## **Note to JRPP Meeting: DA2015/0368 2015NTH014**

### **Draft Conditions of Approval – Possible amendments**

Council officers discussed certain draft conditions for approval of the Depot with the applicant and points of agreement and changes are noted below

Figure 3: Recommended Noise Control

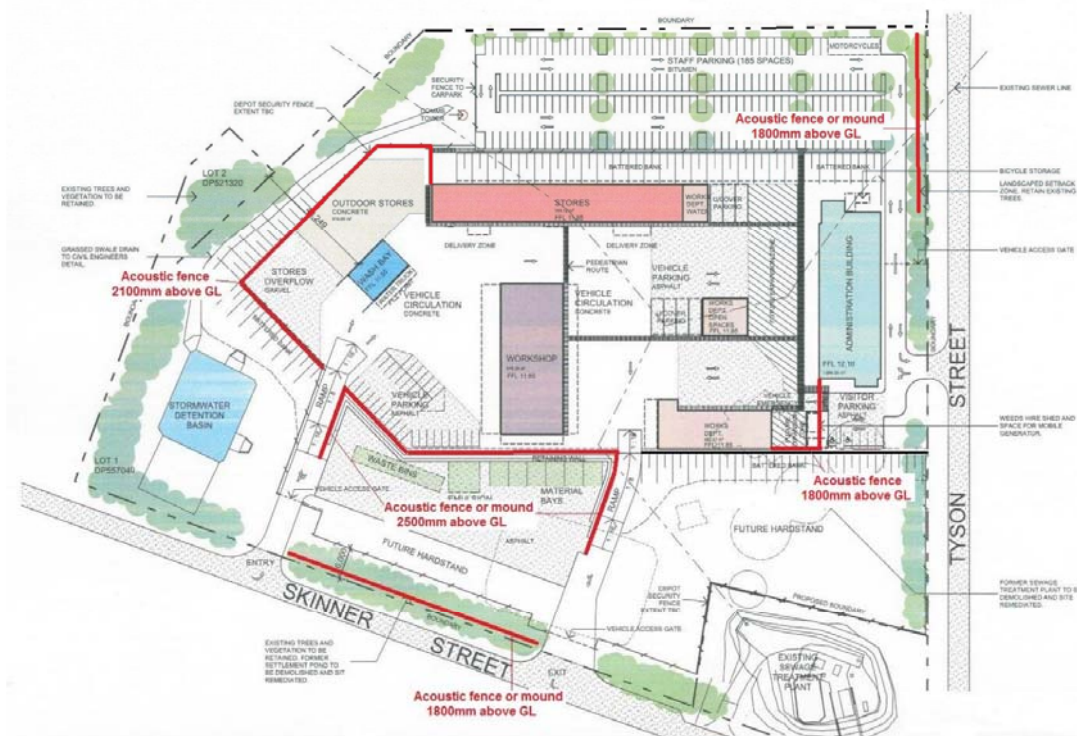
#### **Condition 24.**

The condition should be amended to accord more closely with the recommendation of the submitted acoustic report. (The Plan referred to is attached) and new wording of this condition is recommended as follows:

***Noise control measures are to be implemented in accordance with Figure 3, section 5.1.1 Noise Control Modification, as shown on page 27 of the Reverb Acoustics Report dated May 2015. The barriers and measures are to be engineered and constructed with regard to ensuring noise is effectively attenuated to comply with the previous conditions related to noise attenuation levels***

**Item 1- Stores Overflow/Outdoor Stores:** Erect a 2100mm high acoustic fence along the north and west edges of the areas. An acoustic fence is one which is impervious from the ground to the recommended height, and is typically constructed from Colorbond, lapped and capped timber, Hebel Powerpanel, earthen mound, mound/fence combination, etc. No significant gaps should remain in the fence to allow the passage of sound below the recommended height. Other construction options are available if desired, providing the fence or wall is impervious and of equivalent or greater surface mass than the above construction options.

**Item 2 – Material Bays/Waste Bins:** Construct an acoustic fence or earth mound 2500mm above ground level along the north south and east edges of the areas. We understand that retaining walls are proposed along the north, south and east edges of this area. The recommended fences or mounds will not be required if the retaining walls are equivalent or greater in height than specified.

**Item 3 – Tyson Street Entry:** Construct an acoustic fence 1800mm above ground level between the Works Depot building and administration building.

**Item 4 – South Site Boundary:** Construct an acoustic fence or earth mound 1800mm above ground level along the south site boundary.
